MEMORANDUM

SUBJECT: Item No 4.5 – DA2023/1232 - 397 Condamine Street, Allambie Heights

Amended Plans

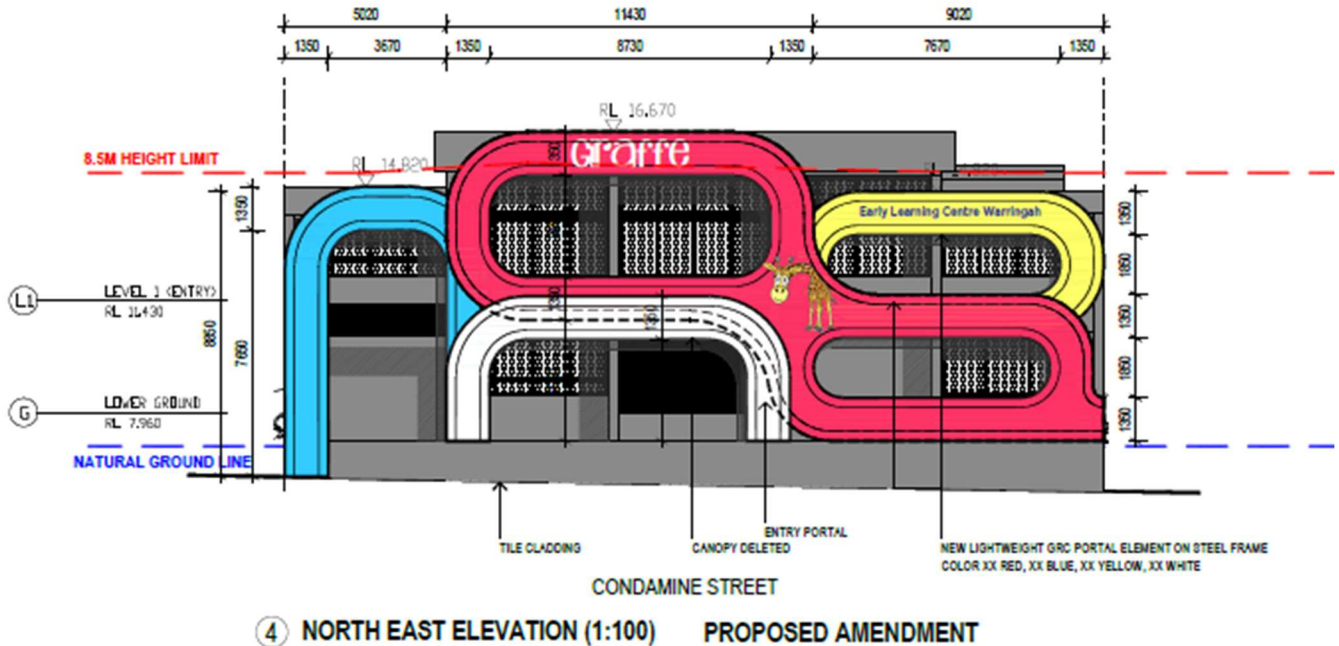
On 21 February 2024, amended plans and a revised Clause 4.6 written request were uploaded the NSW Planning Portal. The north-eastern elevation of the amended plans is included in the figure below for reference.

The submitted plans have adequately addressed the request from the Panel.

The tallest section of the proposed façade (pink/red with word 'Giraffe') matches the highest point of the building at RL 16.670.

The second highest elements of the proposed façade (Blue and yellow) match the building envelope which is at a maximum height of RL14.820.

The front setback structures have been reduced in line with what the NBLPP requested.

The updated Clause 4.6 request is satisfactory, in relation to the elements of the façade that breach the 8.5m height limit.
